Turbo HD DVR v3.4.50 build160512 (2016-5-27)

Firmware Basic Information	Firmware Version:	v3.4.50 build160512
	SDK Version:	V5.1.6.21 build20160401
	Play Library (PlayCtrl.dll)	7.3.0.0
	player	7.3.0.0
	Web version	V4.0.1 build 160323
	Client version	V2.04.06.14 build20160427

Reason of Upgrade

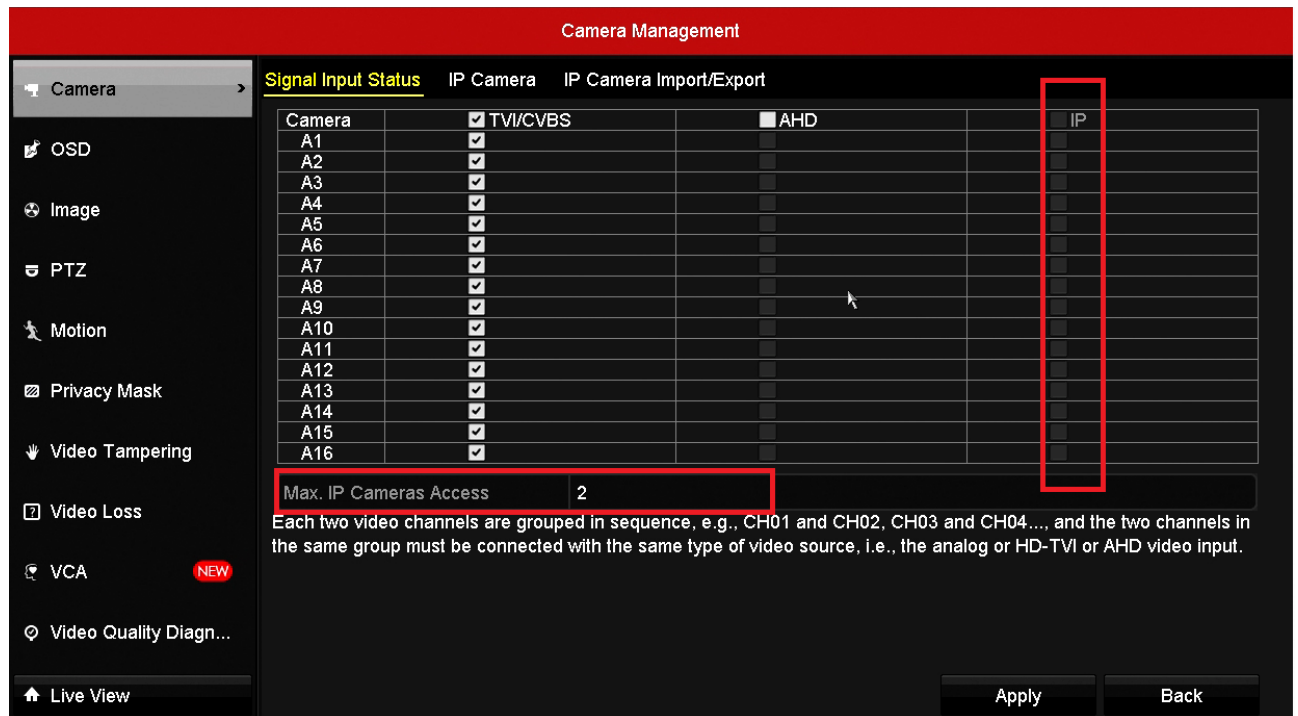
- i. Newly support DS-7216HUHI-F2/N.
- ii. Support self-adaption access of **3MP** cameras. The channel choice of 3MP is removed from **Signal Input**

Status. 3MP cameras can be connected to "TVI/CVBS" channels.

- iii. 72HUHI-Fx/N series device don't support the connection of 5MP signal.
- iv. 72HUHI-Fx/N series device can access 6MP IPC, which used to be 4MP.
- v. **IP channel access** is no more displayed on Signal Input Status. It shows the maximum IP cameras access instead.
